M5 Junction 10 Improvements Scheme

Departures from Standard Report

TR010063 – APP 9.76

M5J10 Departure from Standards Report

DFS 13
120M VISI SPLAY AT 10M CH
INTERVALS IN W/B CARRIAGEWAY

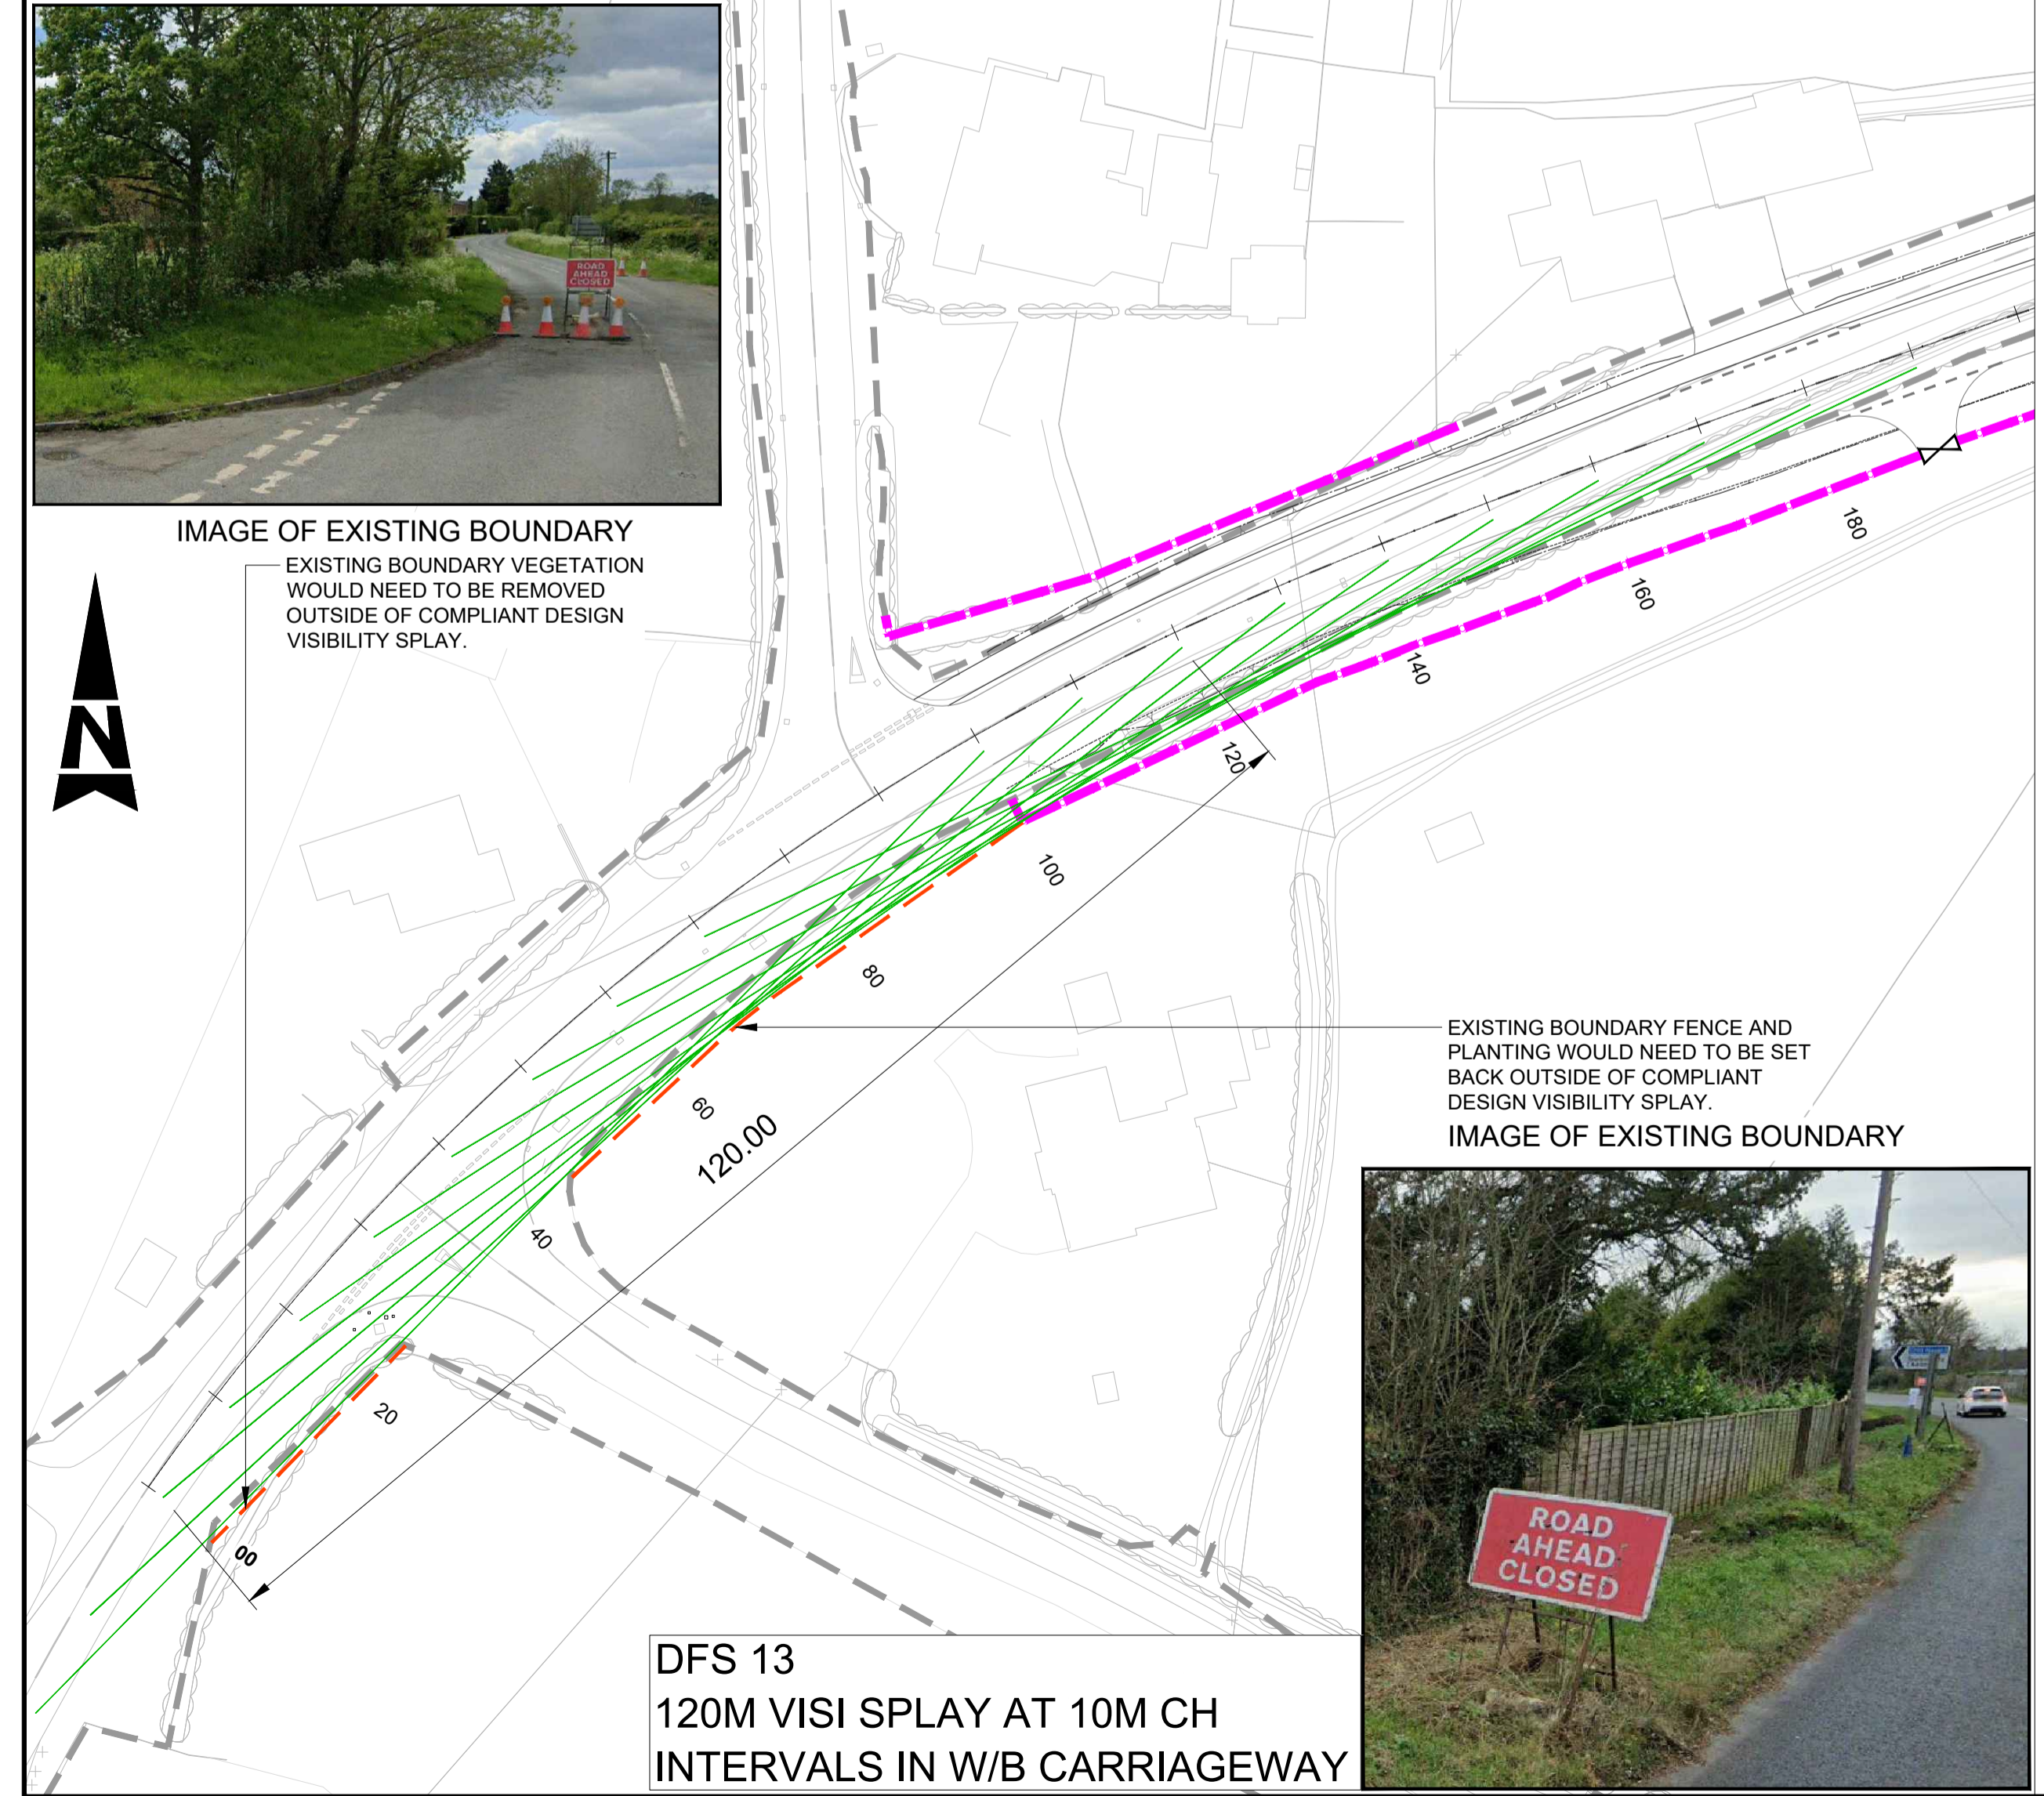
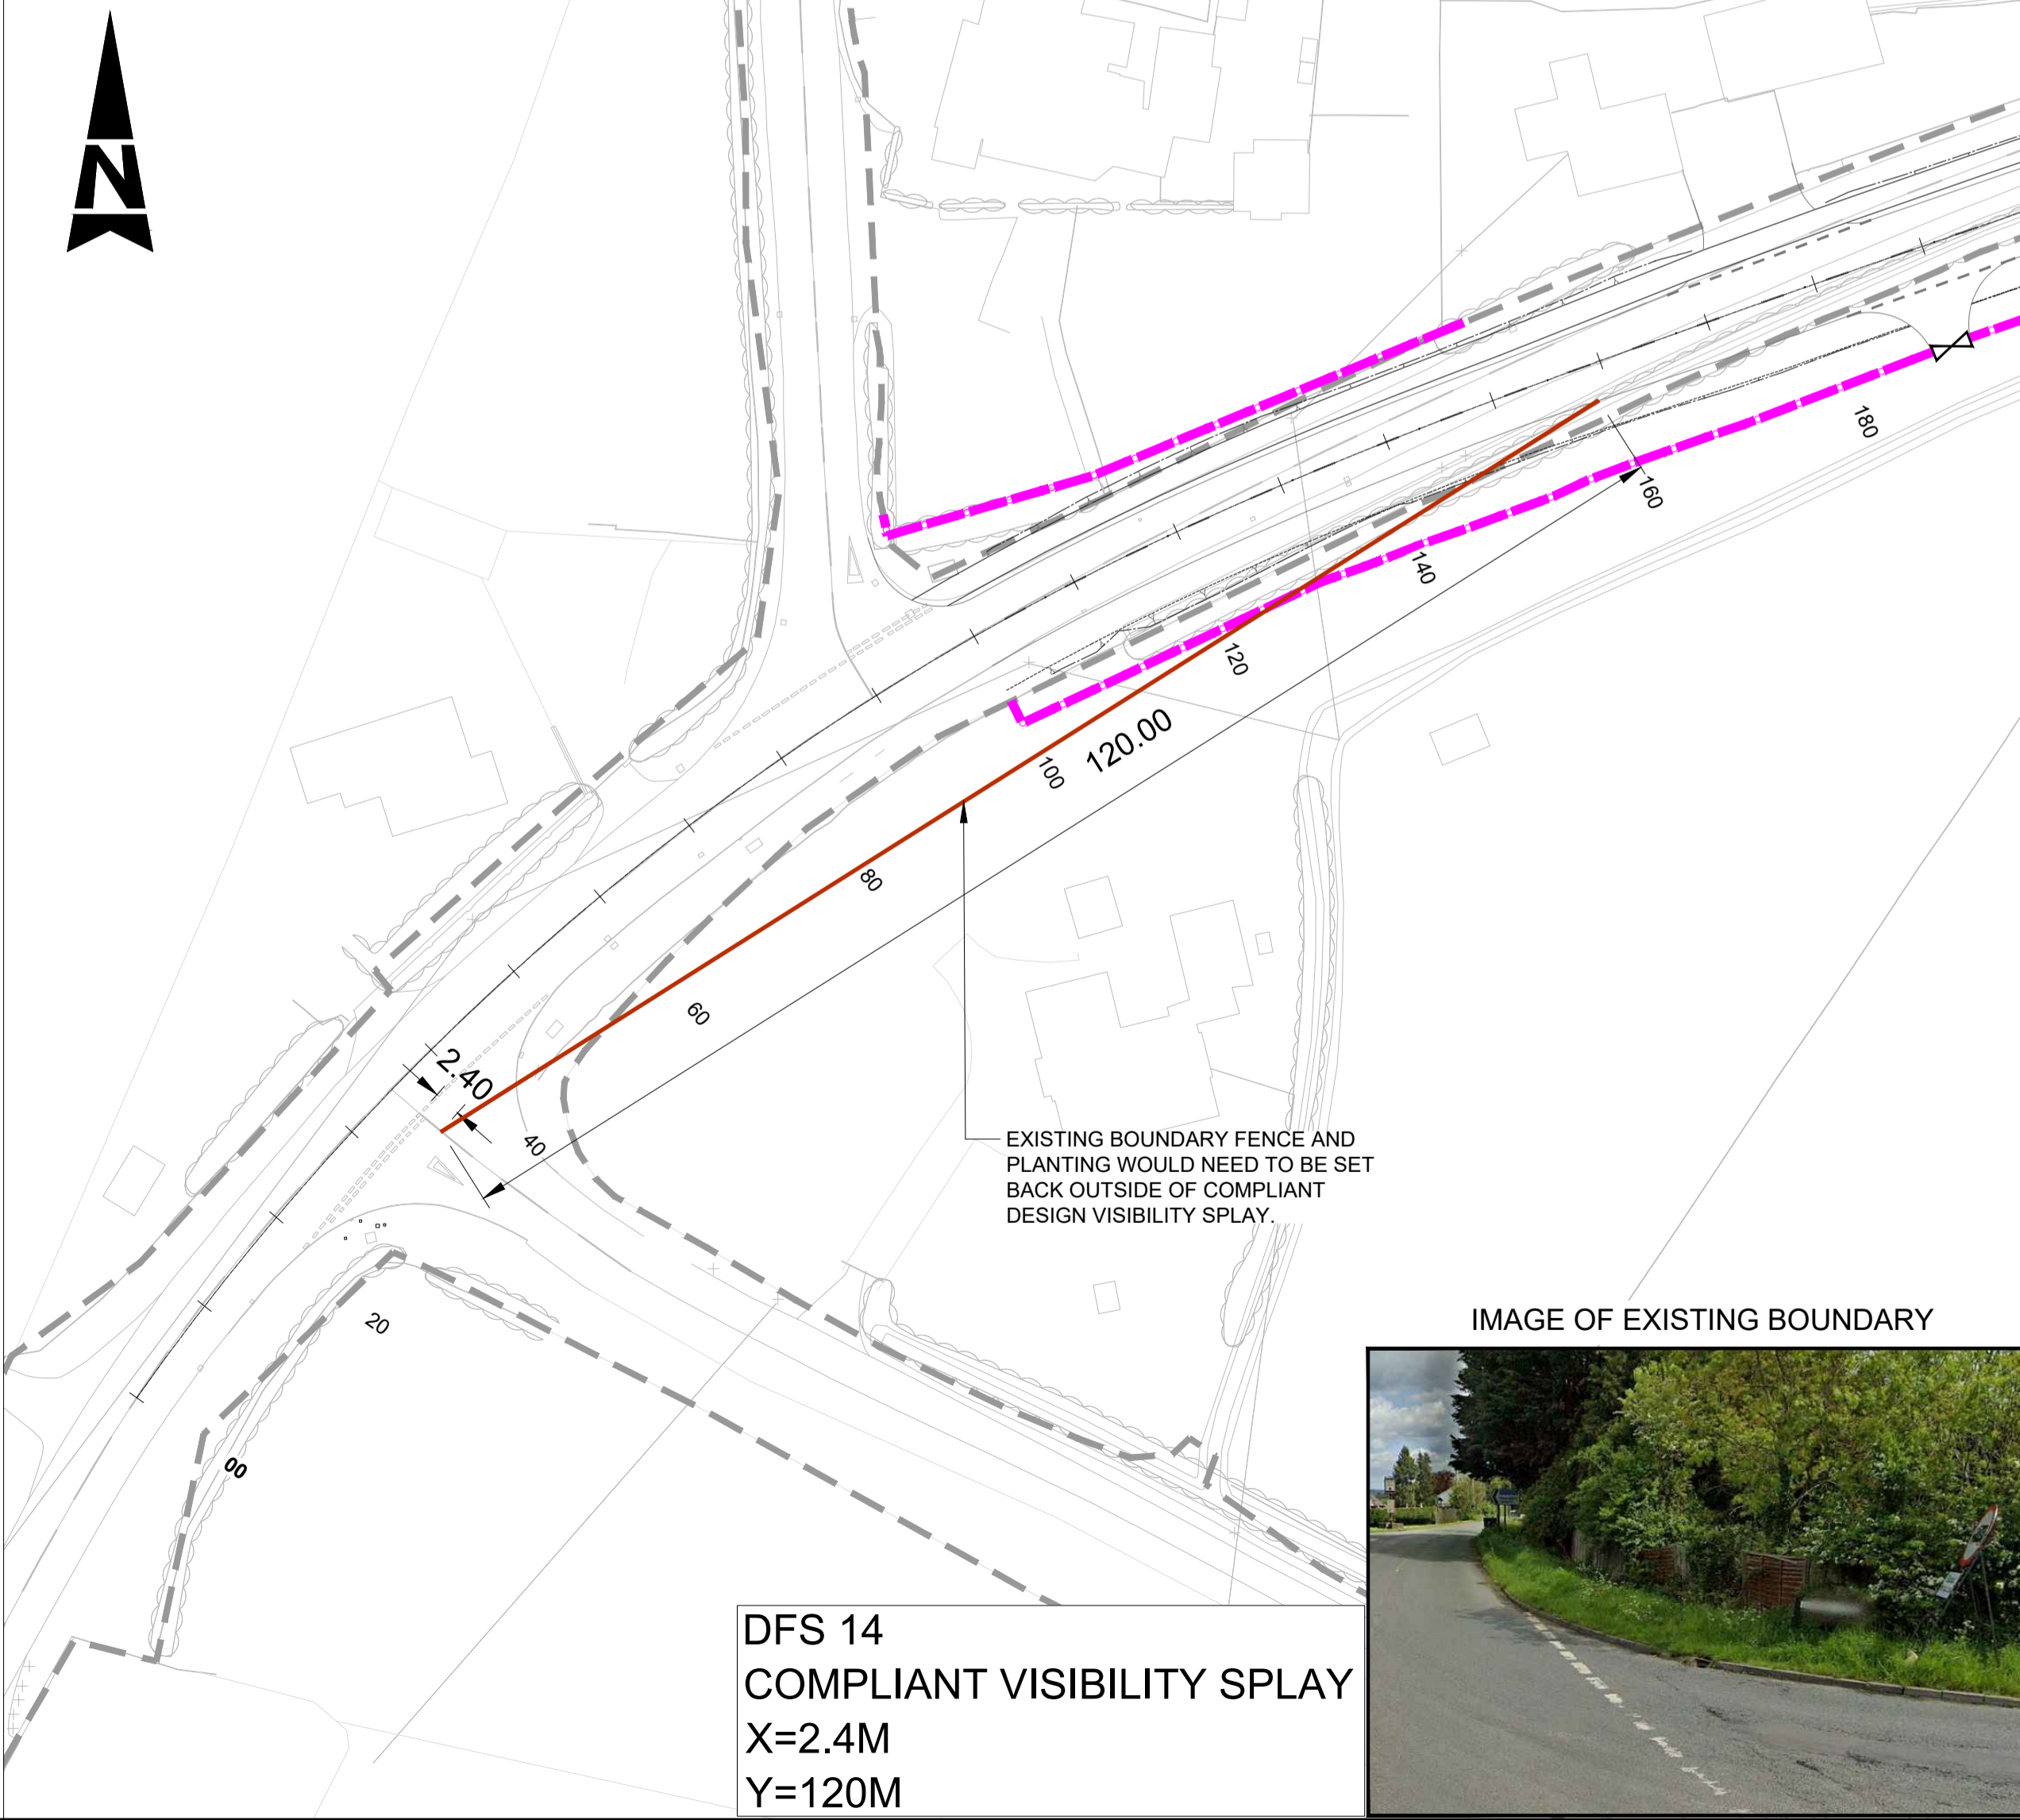
2.6.3. The existing boundary hedge restricts the existing and proposed visibility to the east. In order to achieve a compliant design, the hedge would need to be trimmed back to its centre point. If that is not possible, then an approximate length of 60m of hedge would need to be removed/replanted behind the visibility splay. Replanting a hedge behind the compliant visibility splay would involve additional scheme land-take outside that of the current red line boundary.

2.6.4. The compliant design requirements are shown in Drawing No. GCCM5J10-ATK-HGN-ZZ-SK-CH-000020 in Appendix A.

- 2.7.5. The compliant design requirements are shown in Drawing No. GCCM5J10-ATK-HGN-ZZ-SK-CH-000020 in Appendix A.
- 2.7.6. Collision Data for the B4634 between Hayden Hill Farm and the Hayden Lane junction is included in Appendix B.
